GENERAL PLAN AND ELEVATION
BR. 1 001 279

REHABILITATION OF BRIDGES
1 & 1A ON RISING SUN LANE
OVER BRANDYWINE CREEK

ADDENDUM NO. 2	B.K.B. II/05/08
MODIFIED NOTE

CONTRACT	COUNTY	F.A.P. NO.	SHEET NO.	TOTAL SHTS.
21-074-01	NEW CASTLE	EBHN-N279(II)	28	83

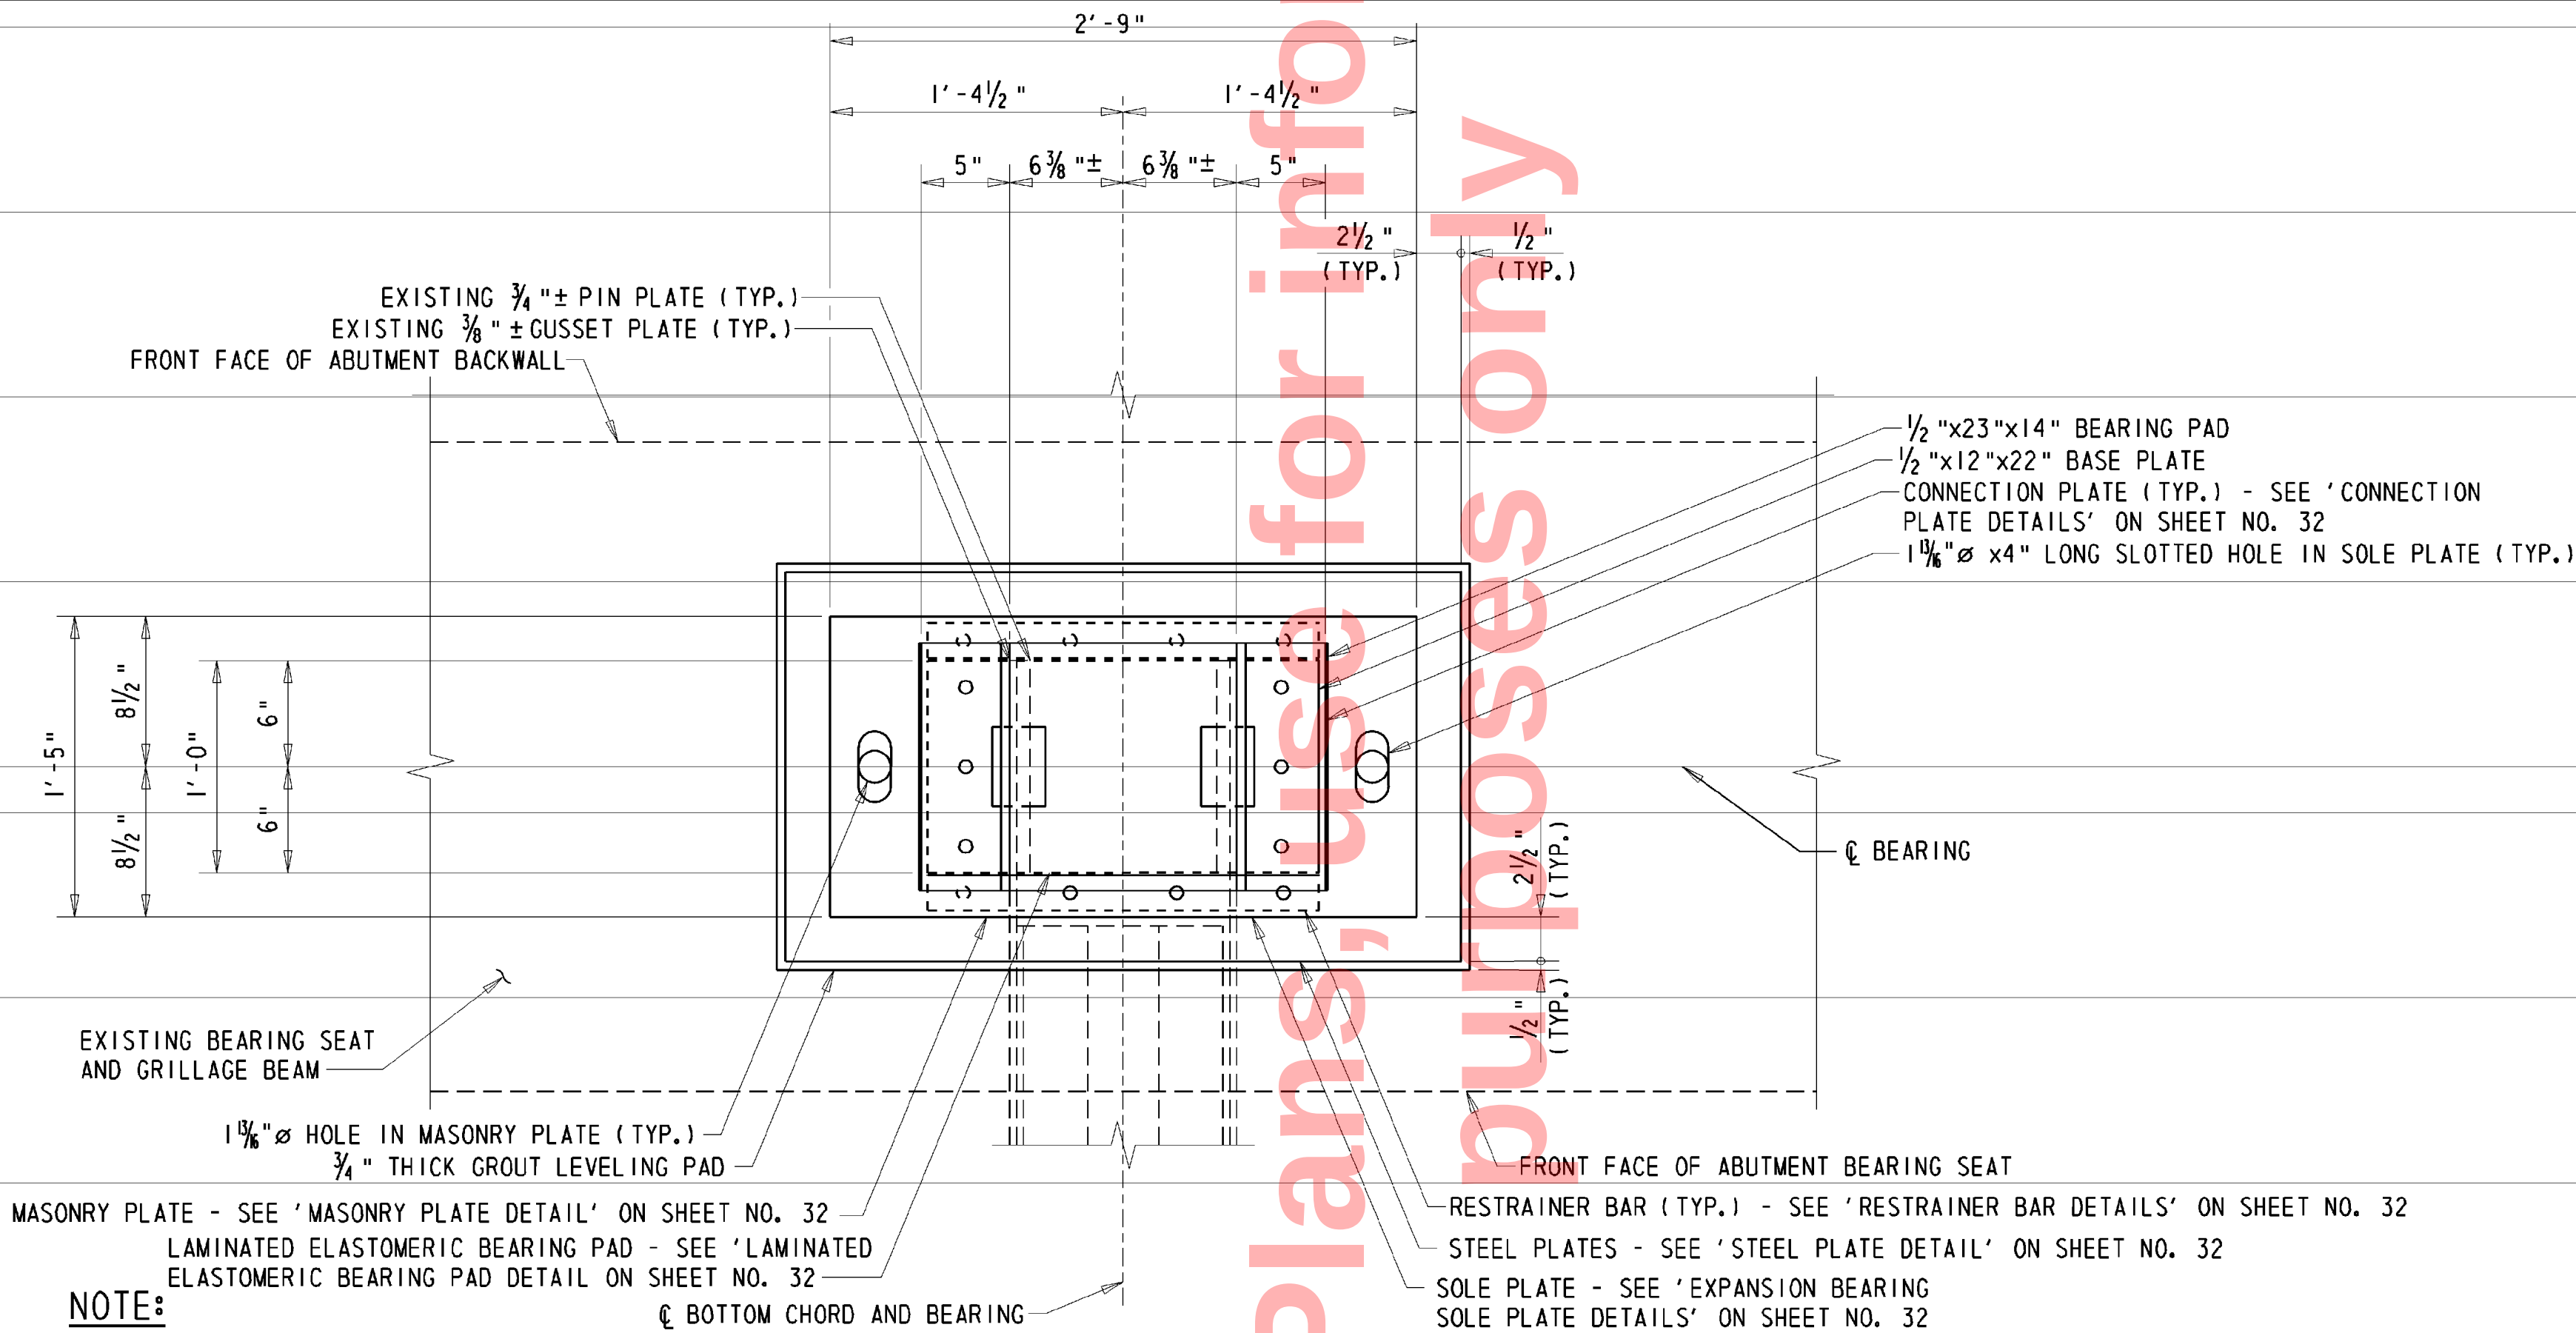
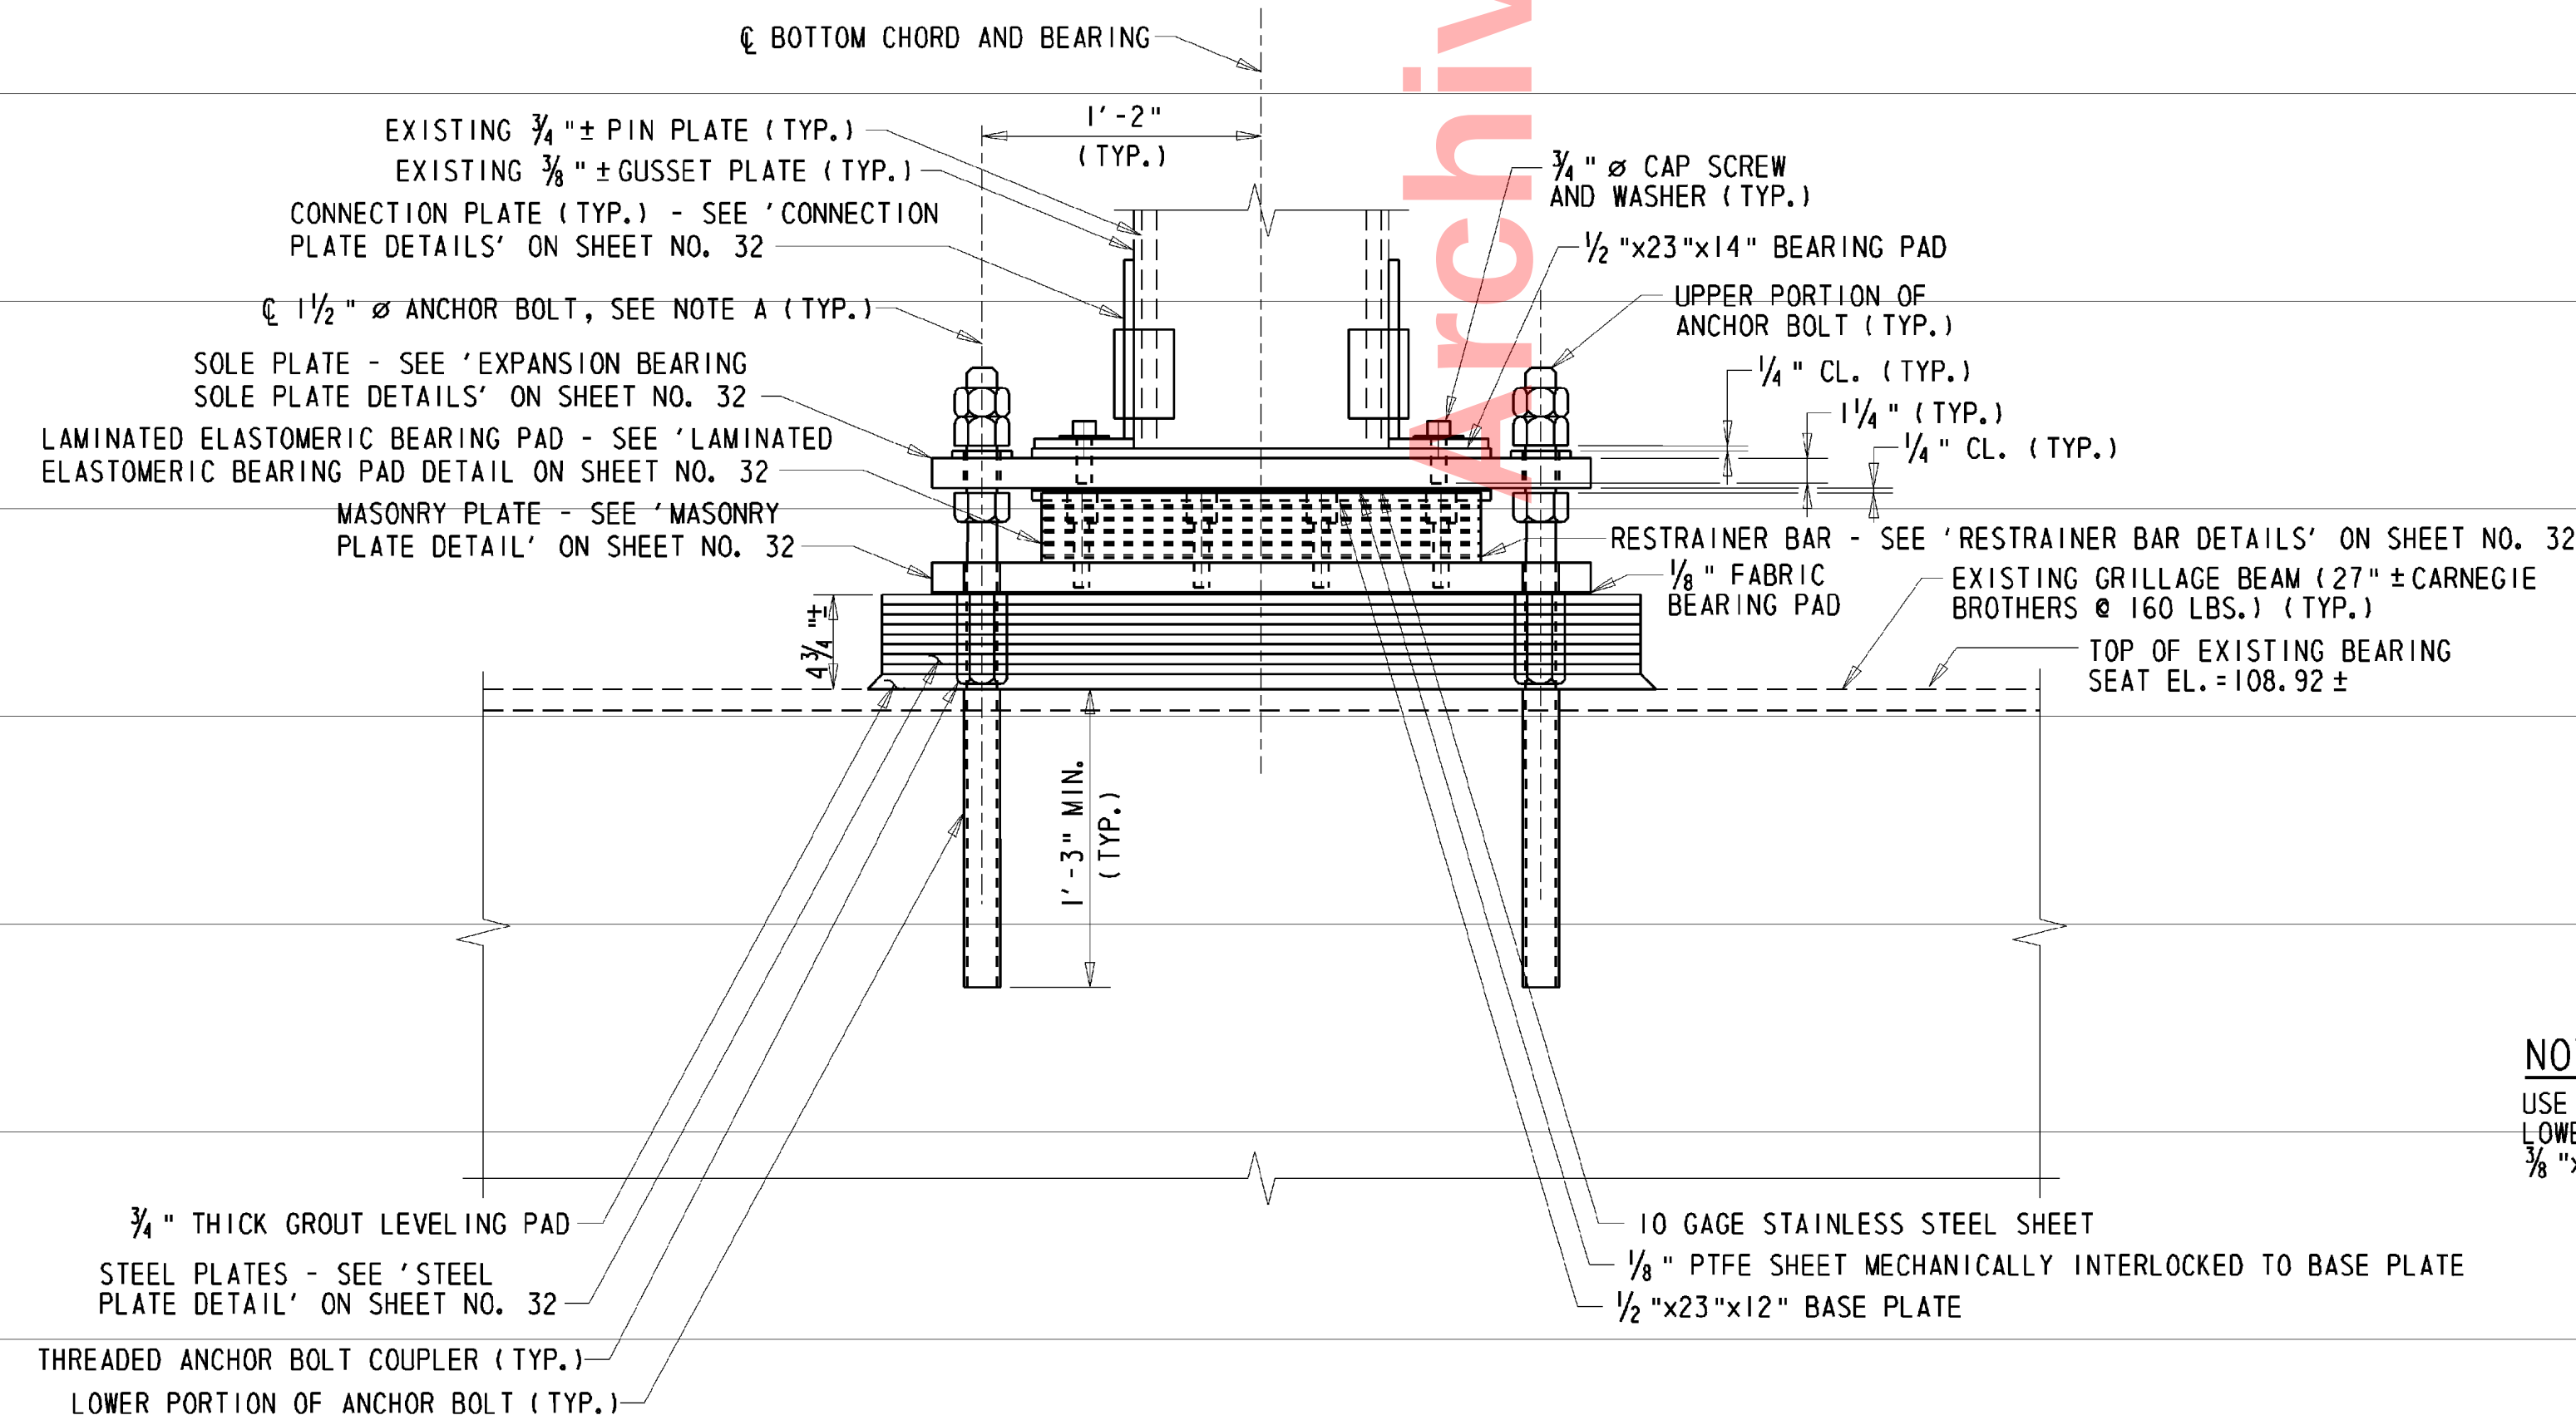
- CONTRACTOR SHALL REMOVE EXISTING COUNTERSUNK AND CHIPPED RIVETS WITHIN GUSSET PLATE AND PIN PLATE SURROUNDING EXISTING 4 1/2" ± DIAMETER PIN. DIMENSIONS FOR CONNECTION PLATE AND LOCATIONS OF 1/8" ∅ HOLES FOR 3/4" ∅ HIGH STRENGTH TENSION CONTROL BOLTS ARE APPROXIMATE AND BASED ON UTILIZING THE LOCATION OF THE EXISTING COUNTERSUNK AND CHIPPED RIVET HOLES. THE LOCATION OF THE EXISTING COUNTERSUNK AND CHIPPED RIVETS SHALL BE VERIFIED IN THE FIELD PRIOR TO ORDERING OR FABRICATING MATERIALS.
